SERVICE BULLETIN BUC

B-021A July 12, 1999

SAFETY RECALL CODE 0814 - FUEL TANK RETENTION SYSTEM

Figure 1. Original Fuel Tank Mounting Arrangement

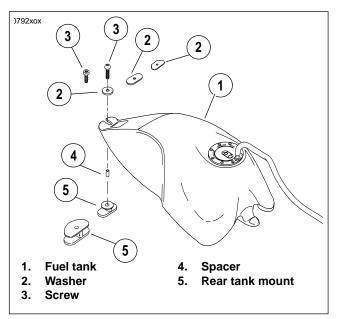
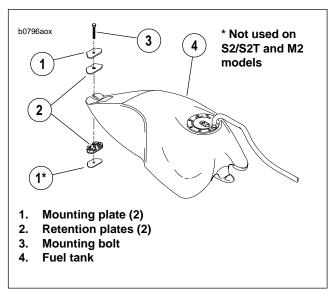
The previous fuel tank retention system recall kit (Part No. 93922Y) fits 1995-96 S2/S2T Thunderbolt, 1999 S3 Thunderbolt and 1999 M2 Cyclone models. Any other models (1997-98 S3/S3T Thunderbolt, 1997-98 M2 Cyclone, and 1996-98 S1/S1W models) that received the previous recall service will require the revised kit (Part No. 93922YA) to be installed. This kit supersedes the previous kit and is suitable for use on all the affected model motorcycles.

See Figure 1. Vehicles being serviced will have varying combinations of tank mounting parts. Once removed, Items 2, 3, 4 and 5 are to be discarded.

- 4. See Figure 1. Remove and discard fuel tank mounting screw (3) and washer (2).
- While securely holding fuel tank, carefully slide rear tank mount (5), with spacer (4), to the rear of the vehicle and away from the tank. Discard mount and spacer.

- See Figures 4 and 5. Place the remaining retention plate and mounting plate in position on top of the fuel tank rear mounting projections. Make sure shorter straight side of both retention plate and mounting plate face to rear of vehicle
- 9. See Figure 5. Install **new** mounting bolt (4) and tighten to 18-23 ft- lbs. (24.4-31.2 Nm).
- 10. Wait five minutes and tighten bolt again to 18-23 ft-lbs (24.4-31.2 Nm).
